Microsoft MWH Data Center Air Quality Approval Order 18AQ-E024

Response to Public Comments Report

From July 26, 2018 through August 31, 2018, Ecology accepted public comments on the draft air quality approval order for the Microsoft MWH Data Center expansion, MWH Phases 03/04/05/06. A public hearing was held at the Quincy Community Center on August 27, 2018.

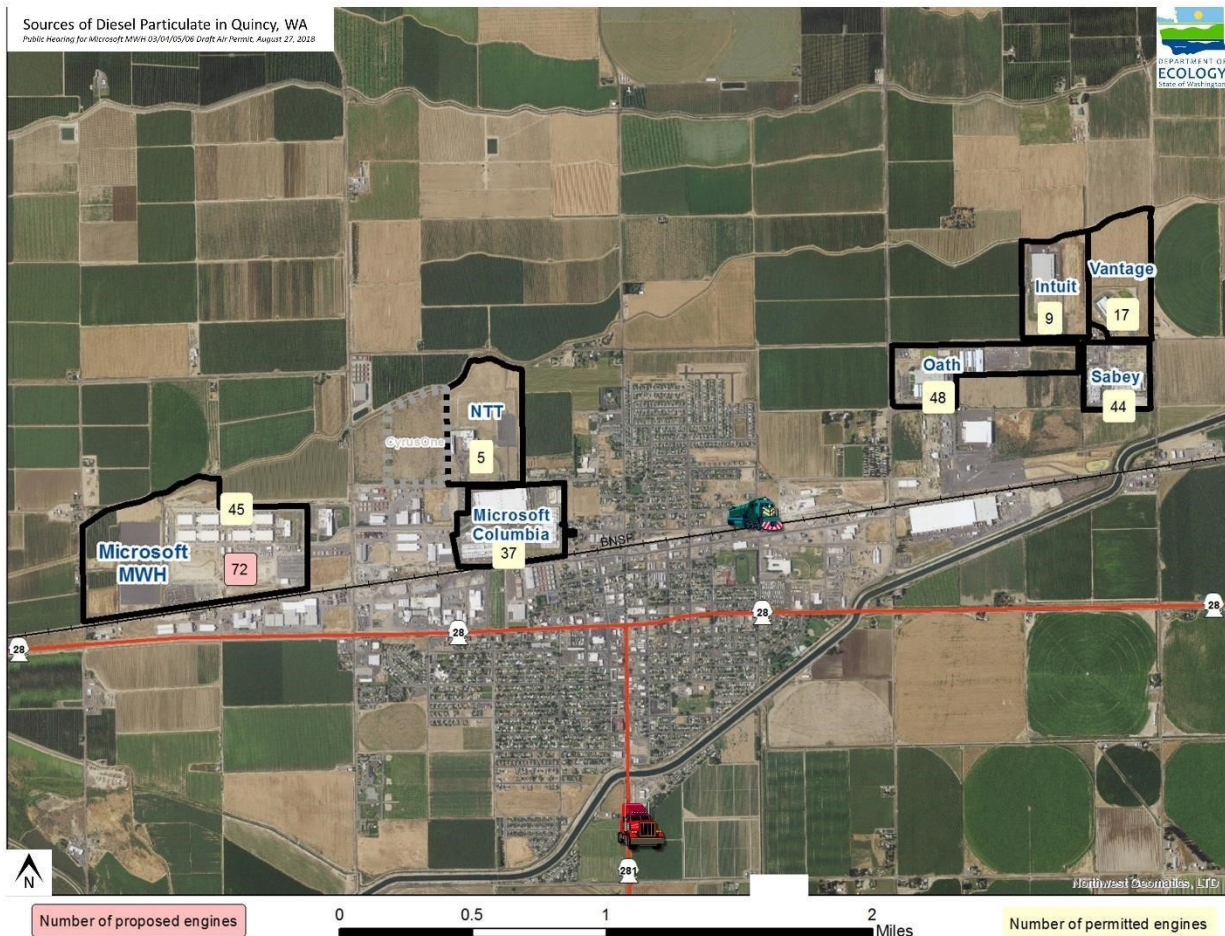
Question: The Health Impact Assessment Recommendation Document, July 2018, has a map on page 27 (Figure 2). The statement at the bottom of the map reads: Residential parcels within the area where proposed MWH- 03/04/05/06 power outage related NO₂ concentrations could exceed the ASIL. No mention is made of the duration of the power outage. I want to know the duration of the power outage that is used to determine his map.

This map was developed to compare to the 1-hr NO₂ toxic air pollutant Acceptable Source Impact Level. The maximum 1-hr concentrations presented in Figure 2 were based on the conservative assumption that the highest NO_x emission rate from each of the 72 MWH 03/04/05/06 proposed engines occurs continuously over a 5 year meteorological period (approximately 44,000 hours). The model determines the highest estimated 1-hr NO₂ concentration over the 5 years (or ~ 44,000 hours) at each receptor location. Figure 2 displays the locations where the maximum 1-hr NO₂ concentration could exceed the ASIL assuming each engine operates at its worst-case (i.e., highest emitting) load. These maxima do not occur at the same time throughout the entire modeling domain. In reality, these engines are not expected to operate at the modeled worst-case loads, nor will they operate continuously as Grant County PUD data suggest power outages are uncommon with a system-average interruption duration of less than 2.3 hours per year.

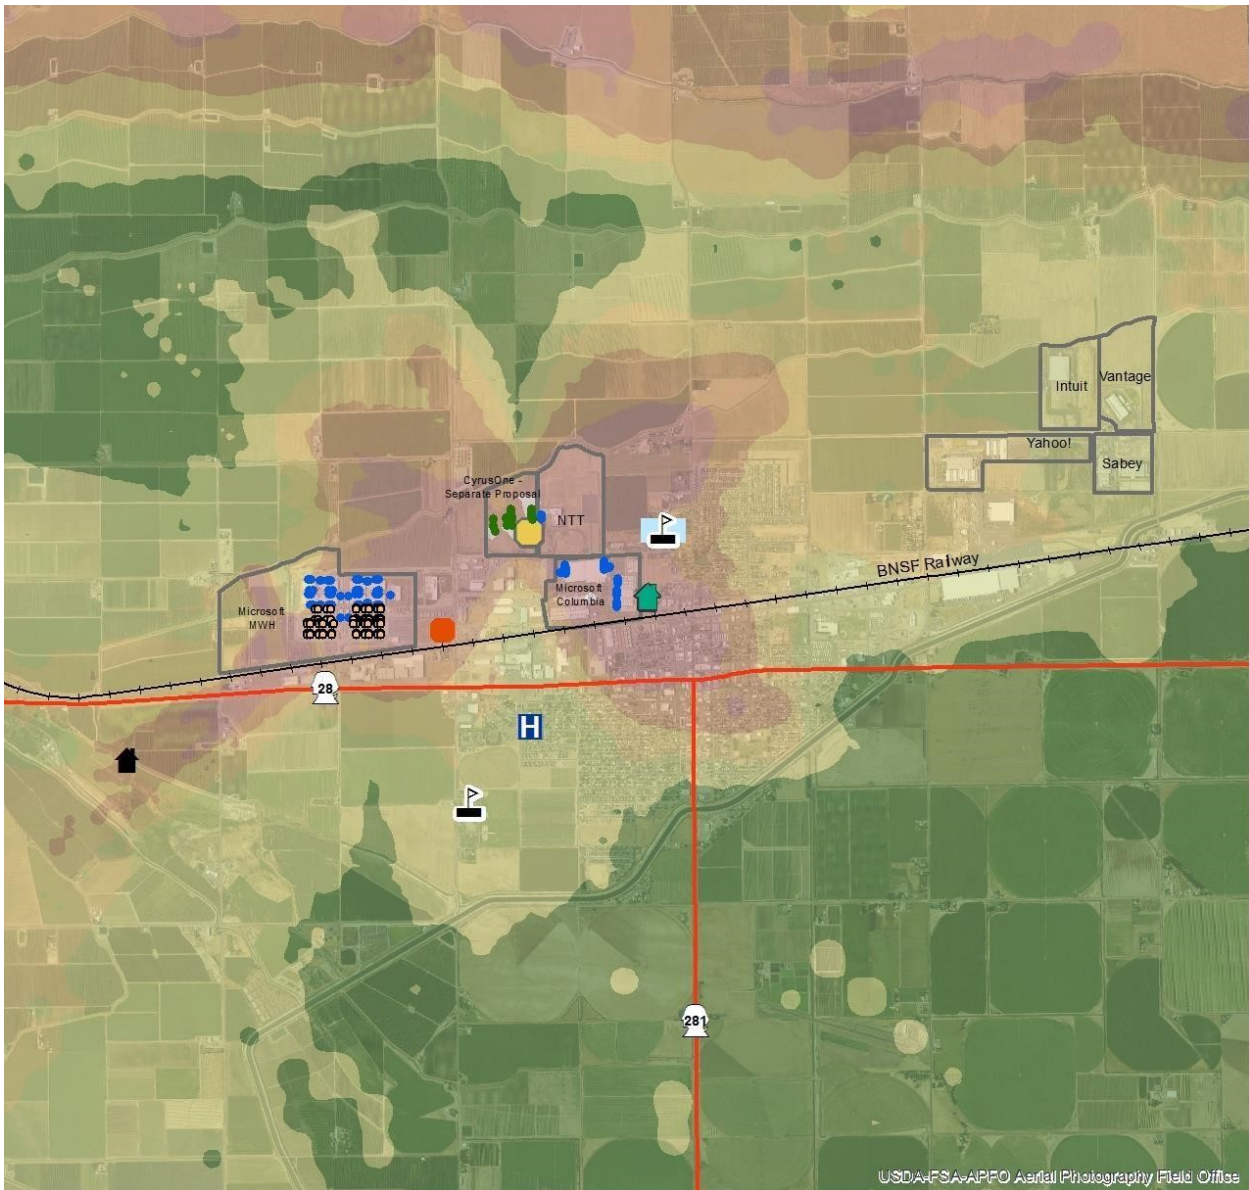
Question: I want a map that shows the dispersion of toxins over the entire city of Quincy, to include a map of DEEP, a map of NO₂.

The map on page 13 of this document reflects maximum 1-hr NO₂ concentrations assuming all west-side Quincy data centers continuously operate all of their permitted and proposed engines at worst-case loads over a 5 year meteorological period (approximately 44,000 hours). The model determines the highest estimated 1-hr NO₂ concentration over the 5 years (or ~ 44,000 hours) at each receptor location. These maxima do not occur at the same time throughout the entire modeling domain. In reality, these engines
